CABINET SERIES PRO – MOUNTING OF VERTICAL EARTHING KIT ART.-NO. K3930V42

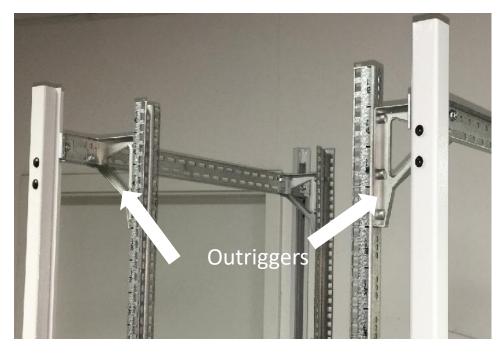
- Mounting solution, to avoid a collision of the earthing bar with the outriggers (profile holders).
- The red insulators for the earthing bar have to be mounted at the rear lateral raster holes at the 19" profiles, instead of outer one.
- Despite the 15 mm lower seat, the busbar clamps can still be attached from the front and rear.
- The earthing bar has 8 holes: 3 at each end and 2 inner holes. The second from the outside and the two inner holes are used for fastening.
